PCN#20181205001.0A

**Pin One Dot Symbolization change – Adding Pin One Dot for Select ~~SC70~~, SOT-23,
and SOT-223 Devices
Information Only**

Date: March 07, 2019
To: TOKYO ELECTRON DEVICE (DSTR) PCN

Current Symbolization (No Pin One Dot)	New Symbolization (With Pin One Dot)
SC70 Example		
SOT-23 3 Lead example		
SOT-23 5 Lead example

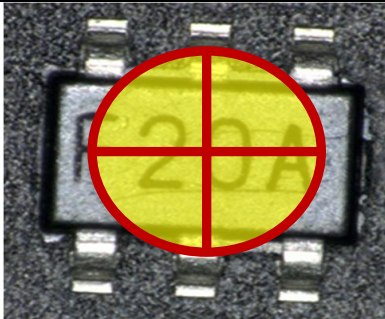
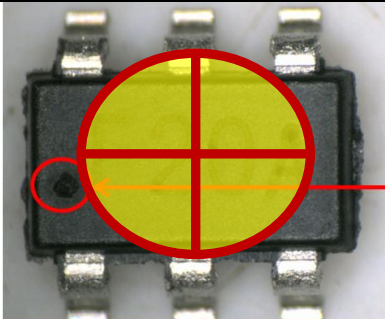
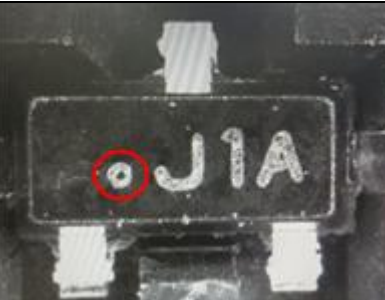
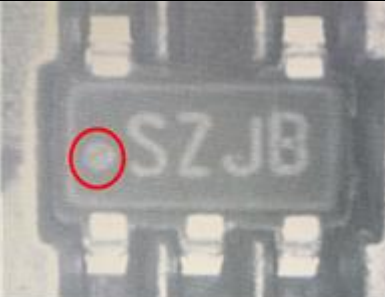
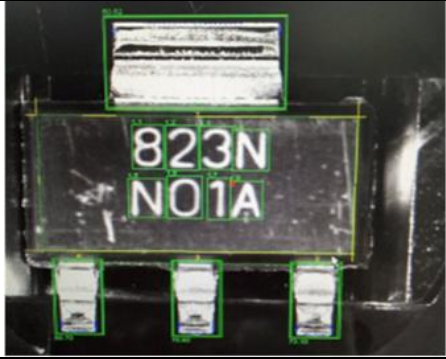
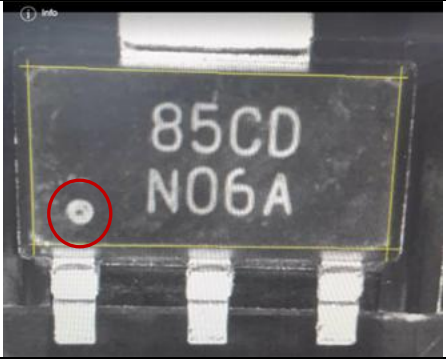
This letter is to inform of the addition of a Pin One dot in the devices symbolization of select **SC70**, SOT-23, and SOT-223 Devices:

Revision A is to remove the SC70 devices from this PCN as they have always had the pin one dot and were inadvertently included in this notice.
